FORM APPROVED
OMB No. 1004-0137
Expires: July 31, 2010**SUNDRY NOTICES AND REPORTS ON WELLS**
Do not use this form for proposals to drill or to re-enter an abandoned well. Use Form 3160-3 (APD) for such proposals.5. Lease Serial No.
NM-0533177-A

8. Well Name and No.
TODD 24 P FEDERAL #169. API Well No.
30-015-276954. Location of Well (Footage, Sec., T., R., M., or Survey Description)
760' FSL 660' FEL Sec 24 T23S R31E10. Field and Pool or Exploratory Area
INGLE WELLS; DELAWARE11. Country or Parish, State
EDDY, NM**12. CHECK THE APPROPRIATE BOX(ES) TO INDICATE NATURE OF NOTICE, REPORT OR OTHER DATA**

PROPOSED PLUG & ABANDONMENT

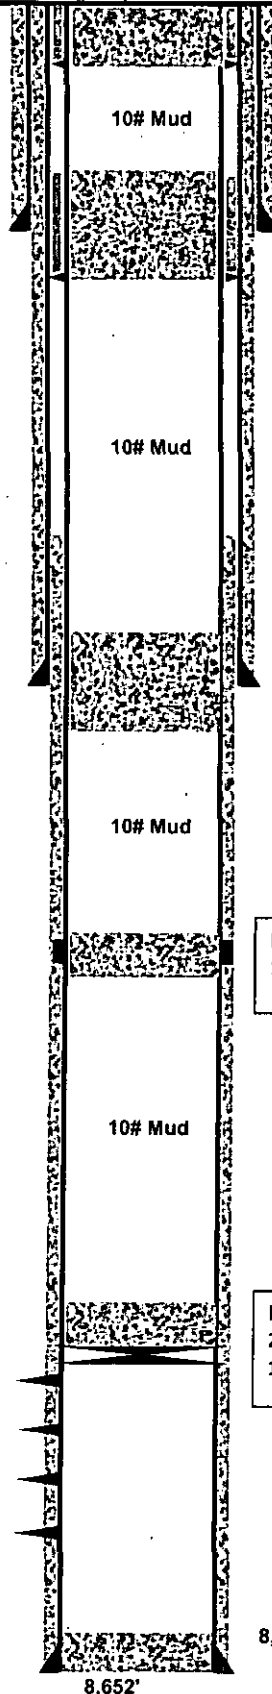
1. MIRU P&A rig. POOH W/rod pump assembly and 2-7/8" production tubing from 8,414'.
2. Set CIBP @ 7,125'. Tag Plug. Spot 25 sx (250') CI C @ 7,125' - 6,875'. (Delaware perms 7,175' - 8,376').
3. Spot 25 sx (250') CI C @ 5,620' - 5,370'. (DV @ 5,517'). *Tag*
4. Spot 40 sx (400') CI C @ 4,600' - 4,200'. Tag TOC. (Bell Canyon @ 4,583'; Shoe @ 4,407'; B.Salt @ 4,315'. Well outside of R-111P).
5. Perf 5-1/2" casing @ 1,275'. Pump 95 sx (400') CI C in/out @ 1,275' - 875'. Tag TOC. (T.Salt @ 1,274'; Shoe @ 939').
6. Perf 5-1/2" casing @ 120'. Pump 30 sx CI C in/out to surface. *7325*
7. Cut wellhead off. Set dry hole marker.

SEE ATTACHED FOR
CONDITIONS OF APPROVAL*Below ground dry hole marker required.*
